**TOWN OF NEWBURGH
PLANNING BOARD
TECHNICAL REVIEW COMMENTS**

PROJECT: WTF NY INC.
PROJECT NO.: 14-07
PROJECT LOCATION: SECTION 2, BLOCK 1, LOT 46 & 42
REVIEW DATE: 29 APRIL 2016
MEETING DATE: 5 MAY 2016
PROJECT REPRESENTATIVE: TALCOTT ENGINEERING DESIGN

Re: WTF NY Lot Line
Town Project No. 2014-17
S-B-L: 2-1-42 & 46
Job No. 13072-WTF

SURVEYOR	ENGINEER	CHARLES T. BROWN, P.E.
		P.O. BOX 4470 NEW WINDSOR, N.Y. 12553
LOT LAYOUT		
LOT LINE CHANGE FOR: WTF NY INC.		
979 & 983 NYS ROUTE 32 SBL: 2-1-42&46 TOWN OF NEWBURGH, ORANGE COUNTY, NY		
DATE 03/25/14	SCALE 1"=30'	JOB NUMBER 13072-WTF
		SHEET NUMBER 1 OF 3

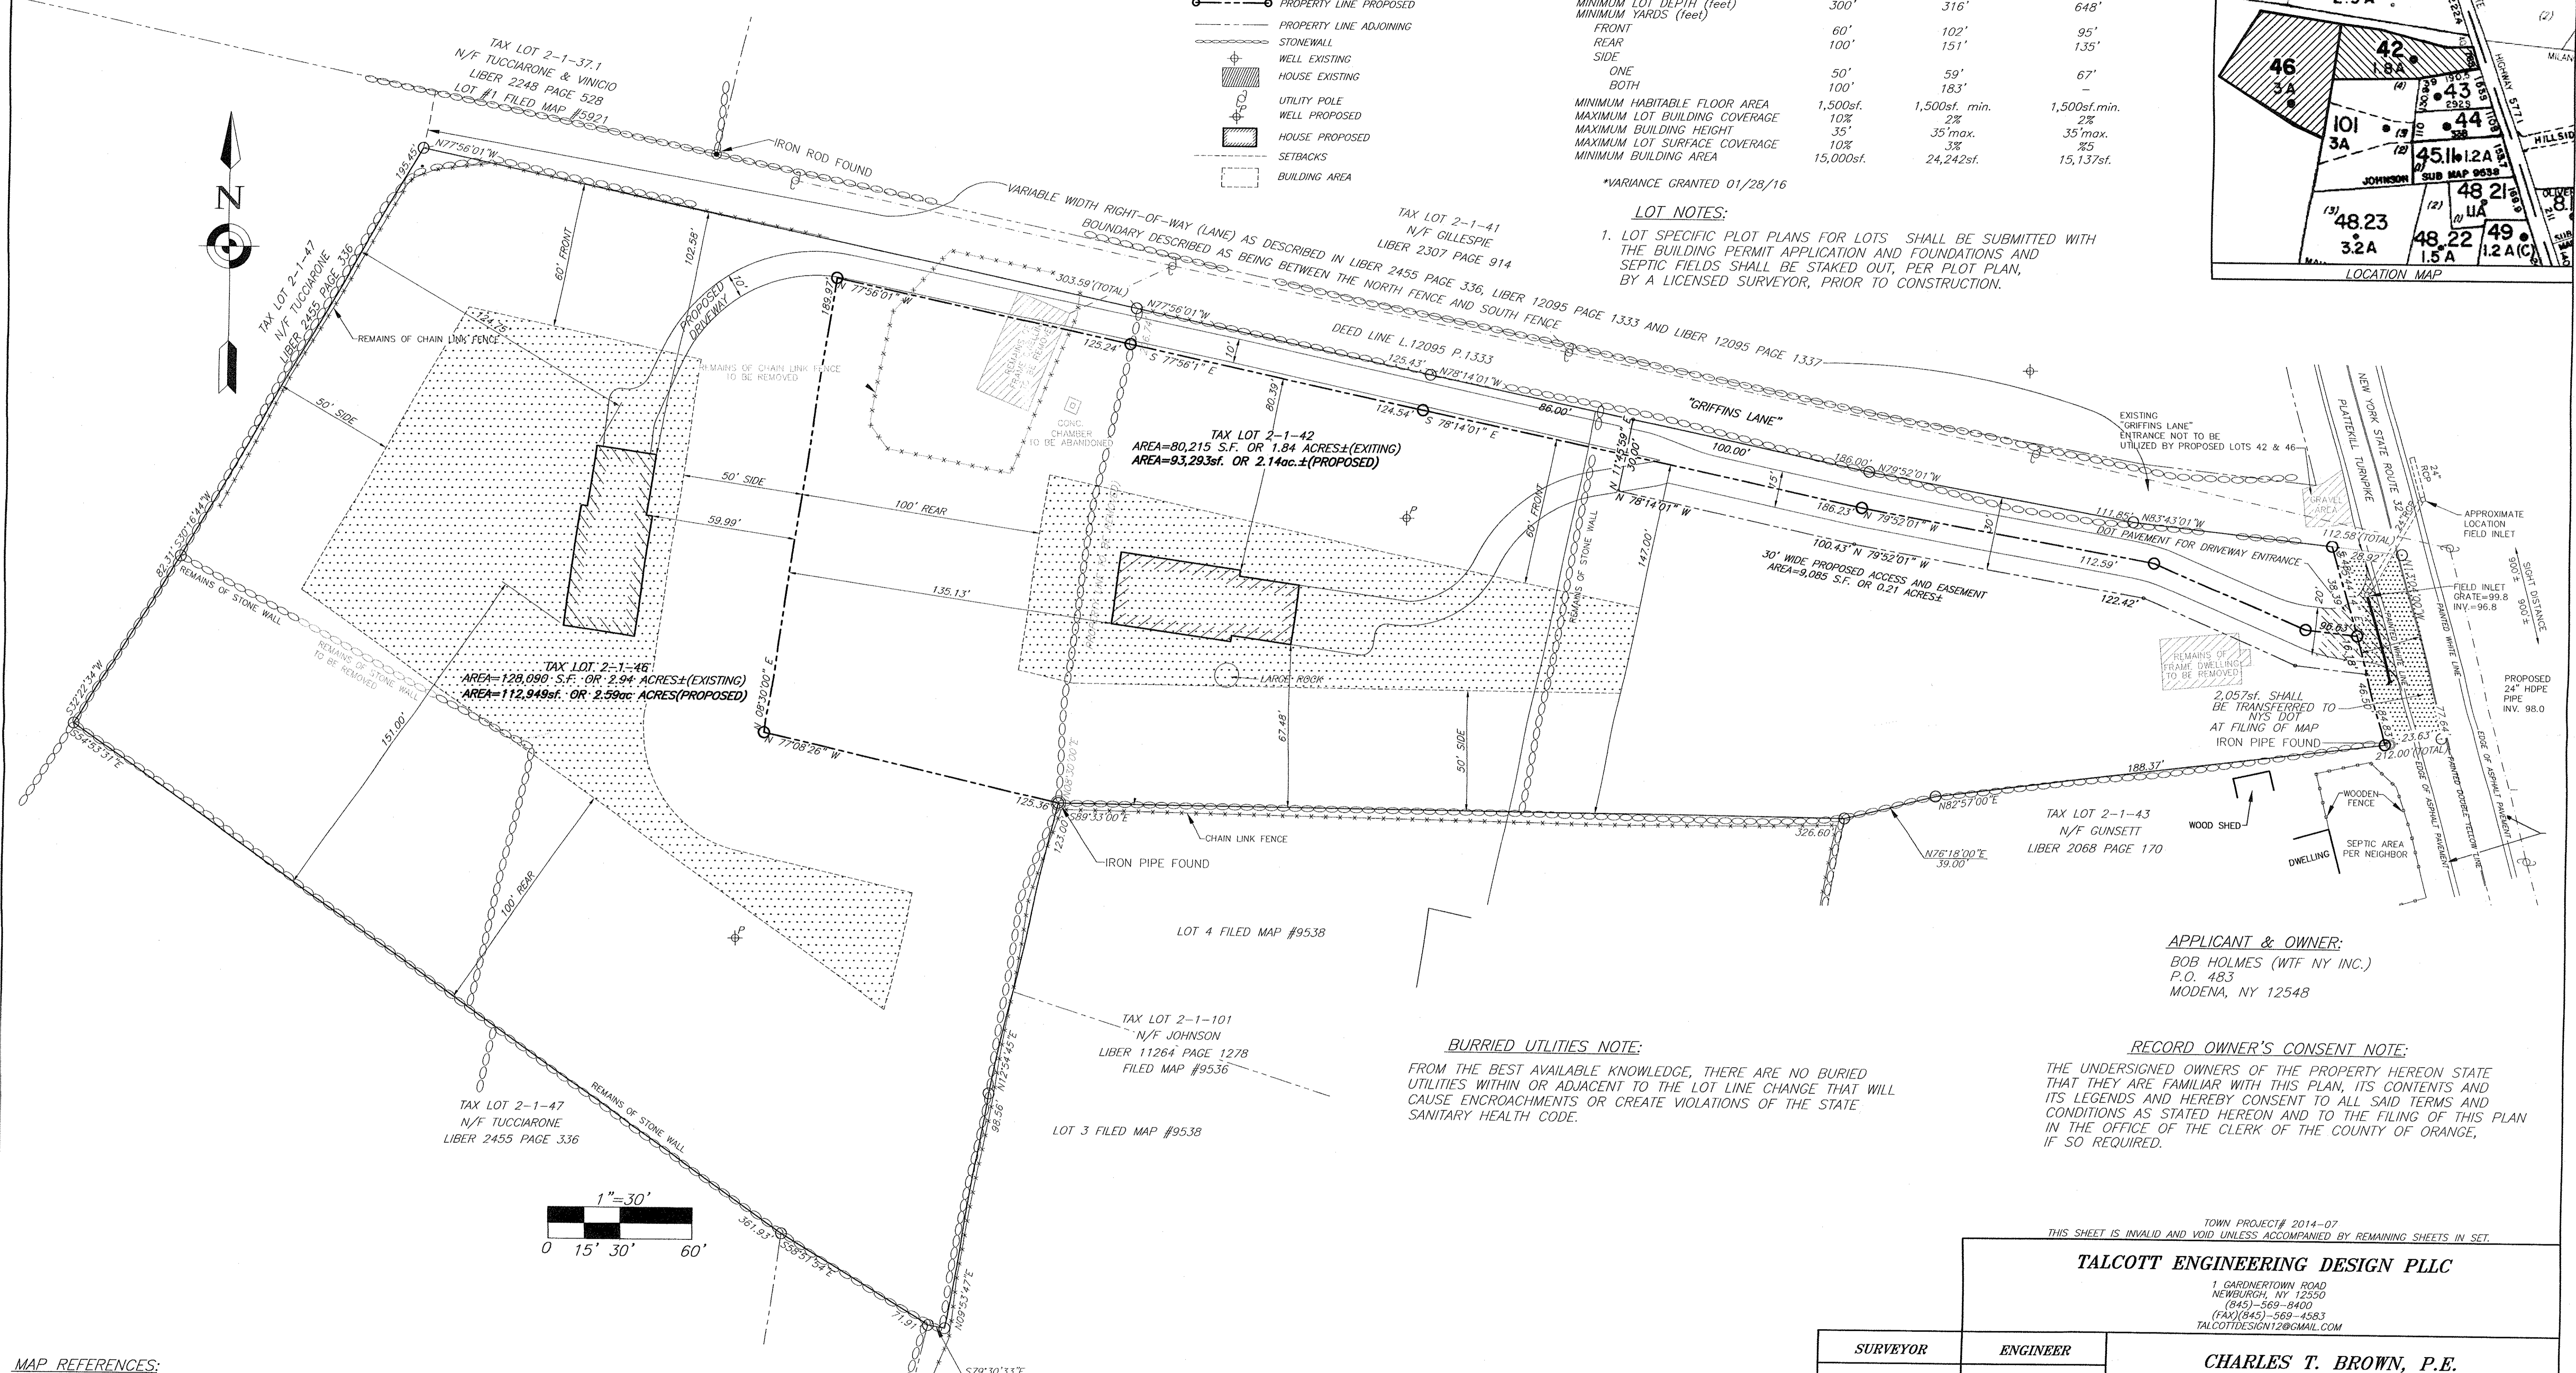
1. This application received conditional final approval on 18 February 2016. Specific condition #2 addressed a requirement that the approval was subject to NYSDOT curb cut and drainage in substantially the same location shown on the plans. Should NYSDOT require changes in either location or configuration from what is shown on the plans(or in proposed drainage) the Applicant must return to the Planning Board for further review. NYSDOT has required just that, such that the Applicant is back before the Board to review the changes requested by NYSDOT.
2. The proposed change has resulted in a 0.1+/- change in lot line sizes reducing tax lot 42 and increasing tax lot 46.

The NYSDOT has required that the proposed common driveway be shifted so as to not impact the adjacent driveway. Based on that, we have adjusted the proposed property lines near NSY Route 32.
